SUNDRY NOTICES AND REPORTS ON WELLS
Do not use this form for proposals to drill or to re-enter an abandoned well. Use form 3160-3 (APD) for such proposals.

AAO FED # 2

API # 30-015-32308

**Apache Corporation
AAO - 02, API 3001532308
T18S-R27E, Sec 01, 430FNL & 2310FWL
September 05, 2016**

GROUP:	Permian North	DATE:	Aug. 04, 2016
FIELD:	Red Lake NE (BP)	BY:	HJG
LEASE/UNIT:	AAO Federal	WELL:	2
COUNTY:	Eddy	STATE:	New Mexico
API:	30-015-32308

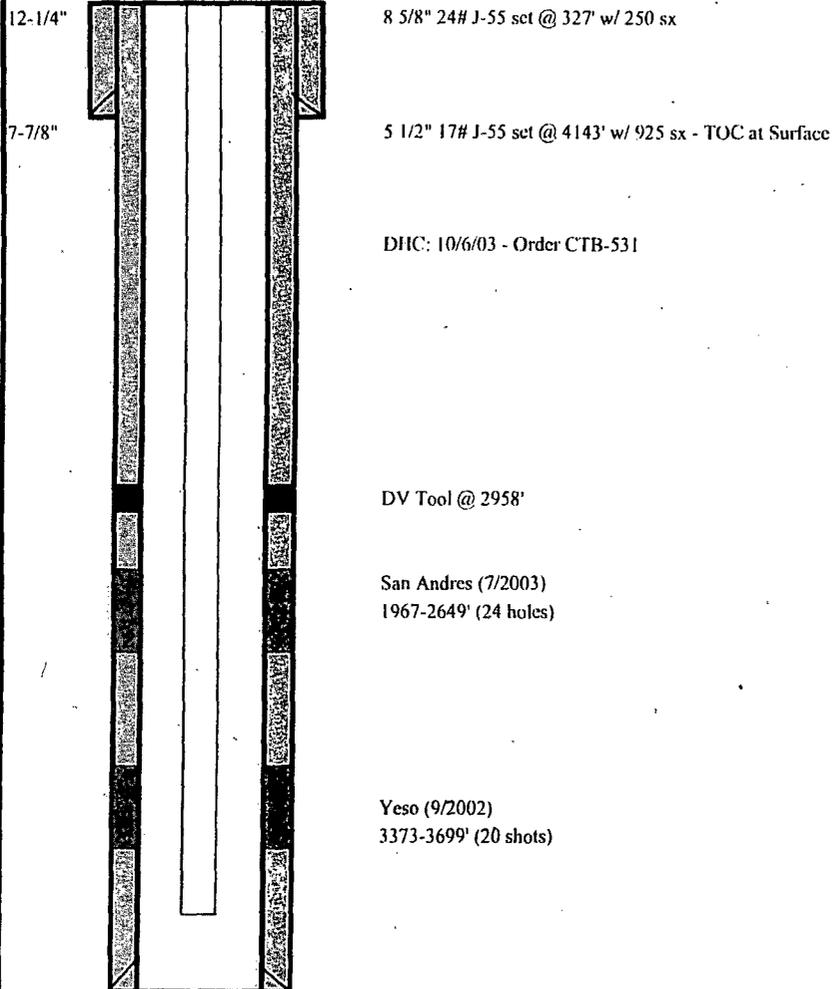
- b. The wellbore below all potential production is to be plugged back per permanent plugging procedures. A bridge plug or packer must be installed as close to 50 feet above any open perforations or open hole as possible. If a cement plug is used, the top of the cement must be verified by tagging. A CIBP set above the top perforations to be permanently abandoned is to be capped with a minimum of 25 sacks cement and placed with tubing, or if the perforations are to be reopened 35 feet of cement may be bailed on the CIBP.
